Exhibit: **A-7**

LANGAN Langan Engineering and Environmental Services, Inc. 989 Lenox Drive, Suite 124 Lawrenceville, NJ 08648 T: 609.282.8000 F: 609.282.8001 www.langan.com NJ Certificate of Authorization No.24GA27996400	Project CAMELOT AT ERNSTON ROAD BOROUGH OF SAYERVILLE MIDDLESEX COUNTY NEW JERSEY	Drawing Title TRUCK TURNING EXHIBIT - FIRE TRUCKS		Project No. 130101101 Date 9/30/2020 Drawn By SLH Checked By KAP	Drawing No. EXHIBIT 1 Sheet 1 of 2
		Drawing No. EXHIBIT 1

LANGAN Langan Engineering and Environmental Services, Inc. 989 Lenox Drive, Suite 124 Lawrenceville, NJ 08648 T: 609.282.8000 F: 609.282.8001 www.langan.com NJ Certificate of Authorization No.24GA27996400	Project CAMELOT AT ERNSTON ROAD BOROUGH OF SAYERVILLE MIDDLESEX COUNTY NEW JERSEY	Drawing Title		Project No.	Drawing No.	
		TRUCK TURNING EXHIBIT - GARBAGE TRUCKS		130101101	EXHIBIT 2 Sheet 2 of 2	
				Date		9/30/2020
				Drawn By		SLH
		Checked By	KAP

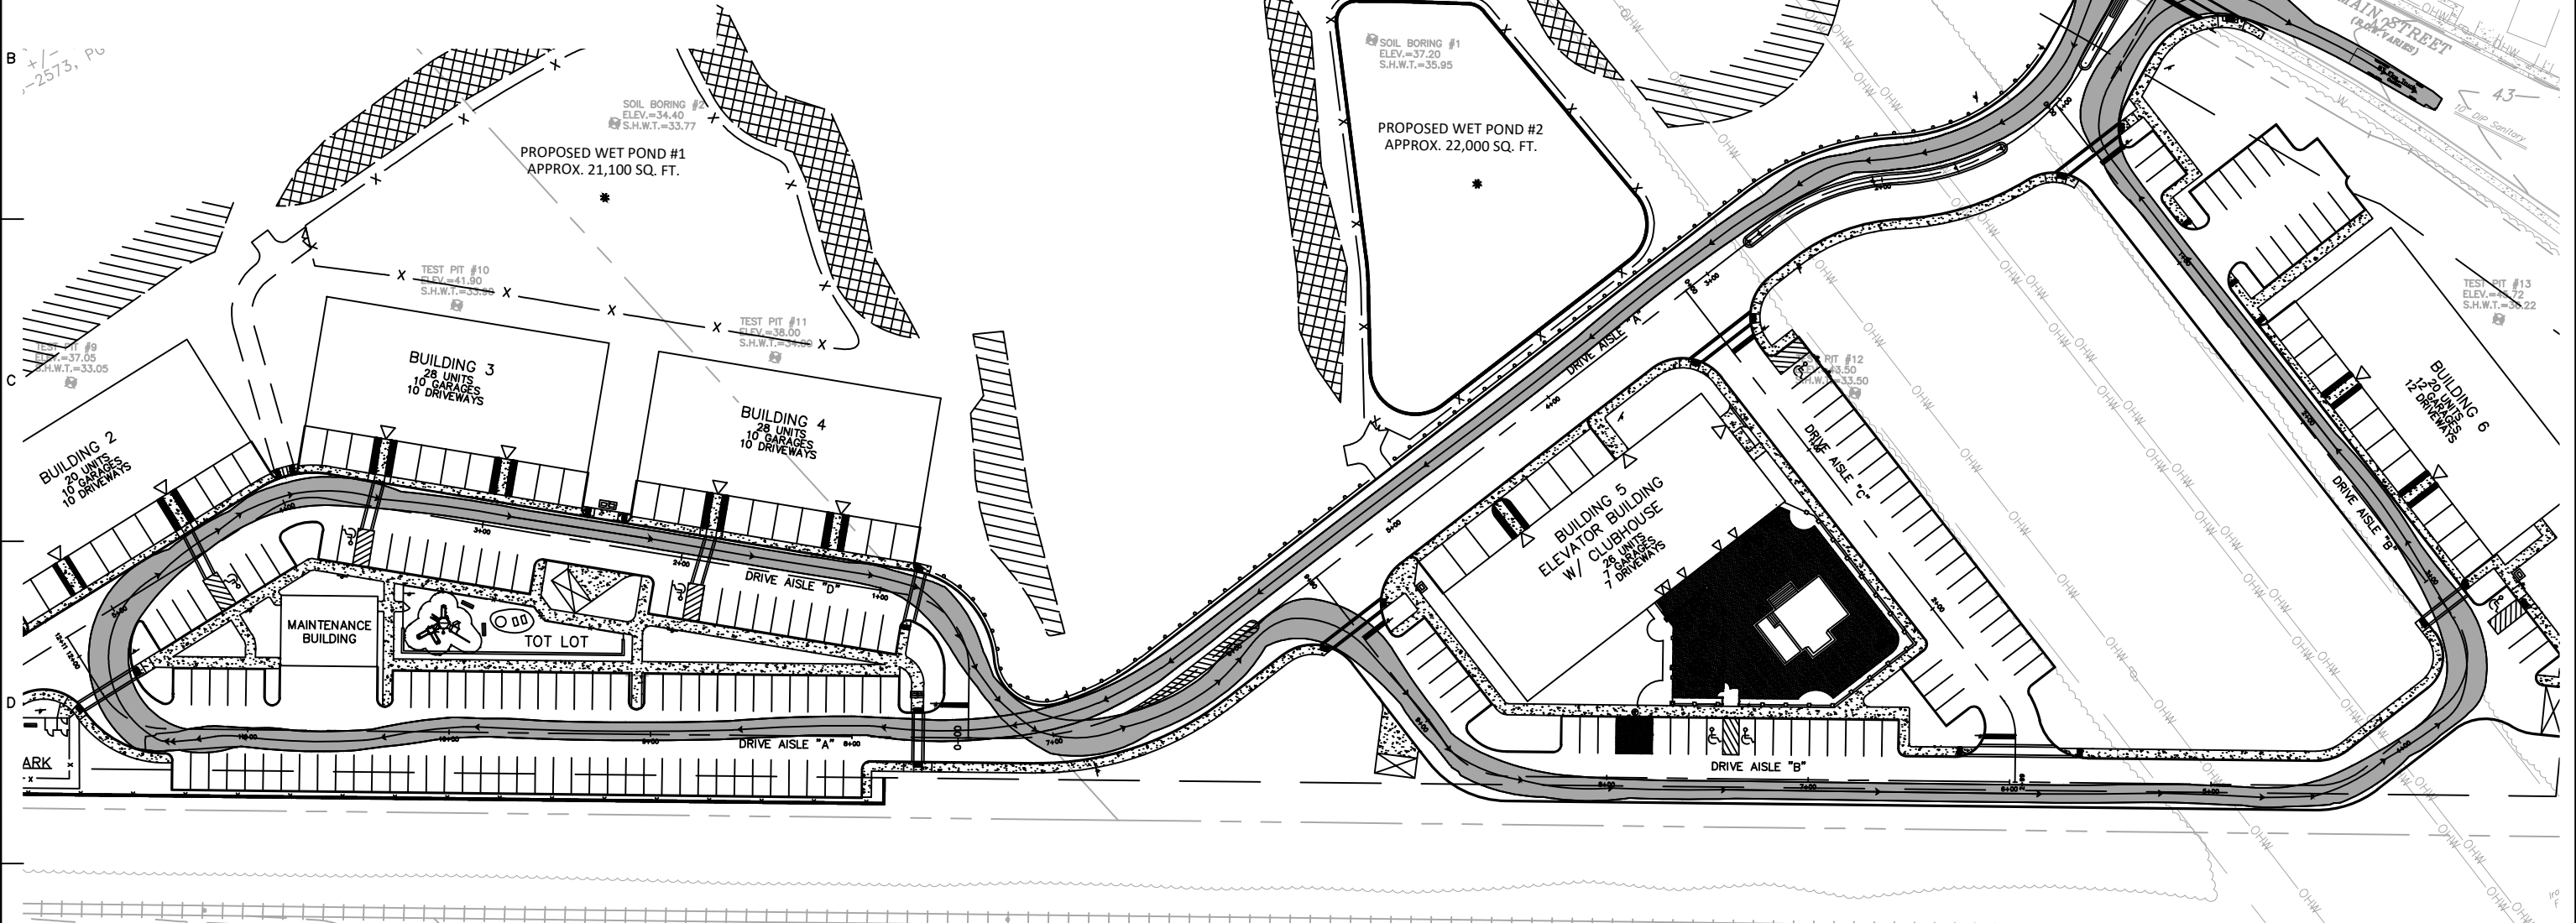
NOTE:
 THIS EXHIBIT PREPARED IN RESPONSE TO CME COMMENT E.2 DATED NOVEMBER 5, 2020. THE FINAL SITE PLAN WILL BE REVISED TO REFLECT THE ADJUSTED DRIVEWAY RADII ON THIS EXHIBIT.

11/20/2020	REVISED CURB RETURN RADII PER CME COMMENT	1
Date	Description	No.

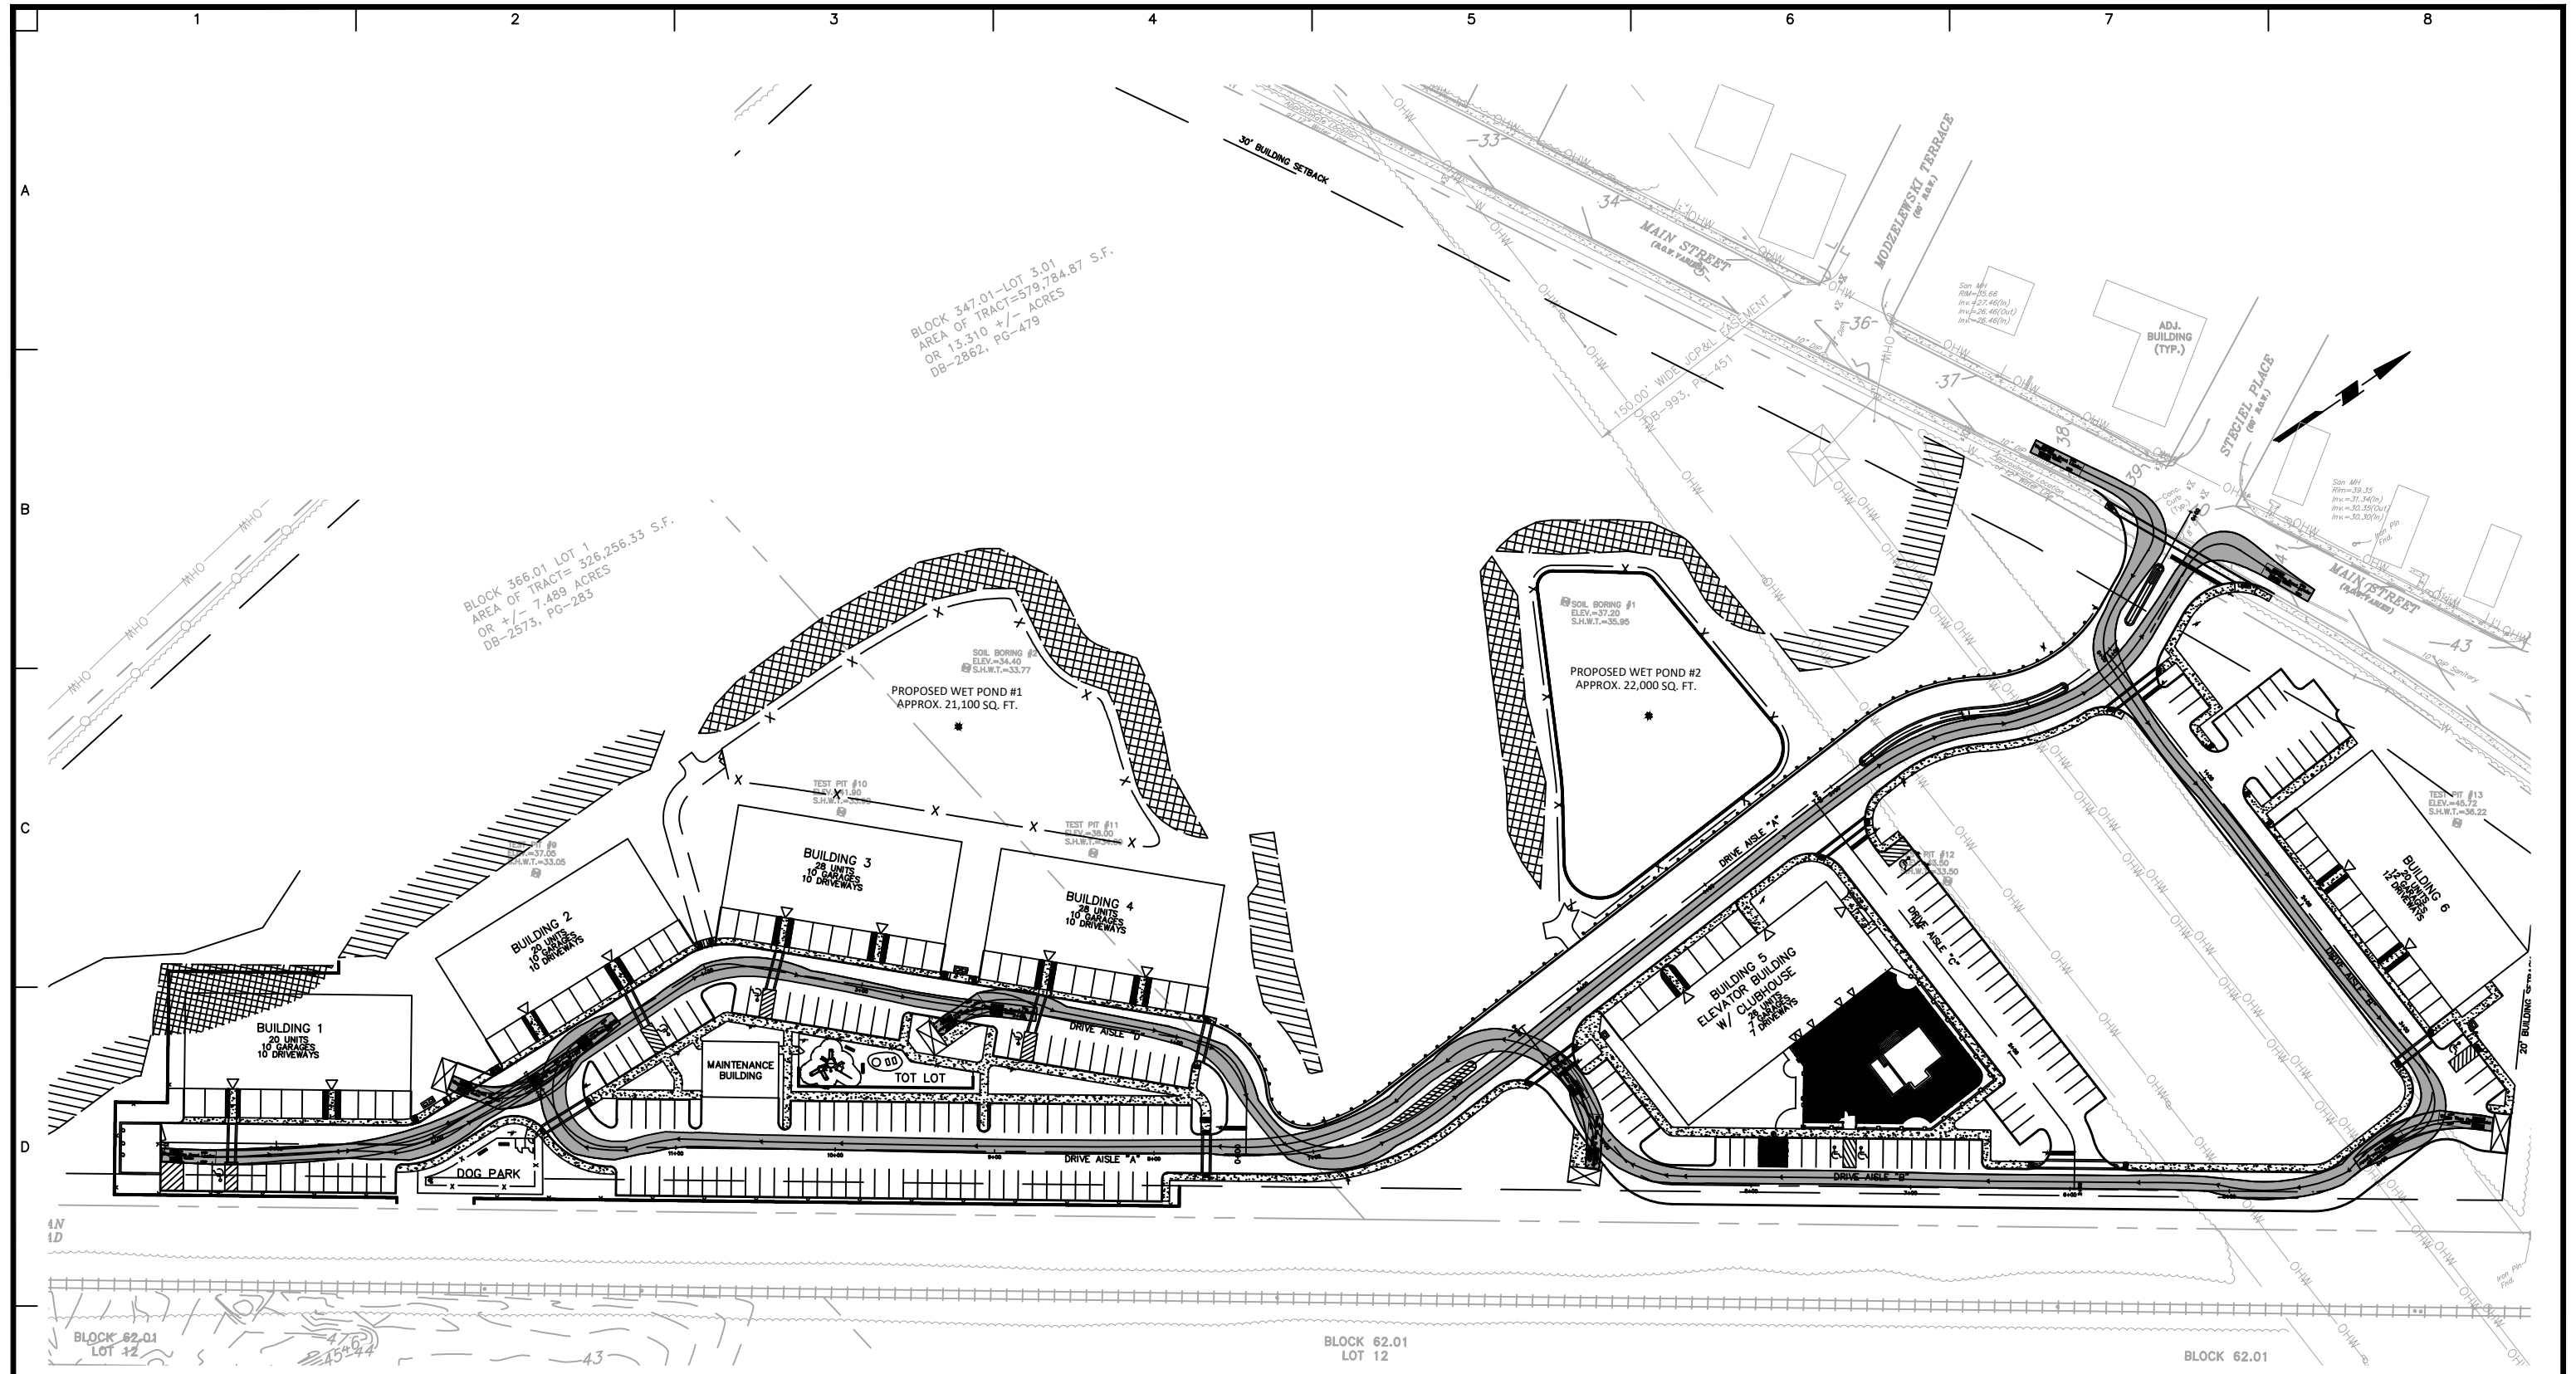
11/20/2020	REVISED CURB RETURN RADII PER CME COMMENT	1
Date	Description	No.
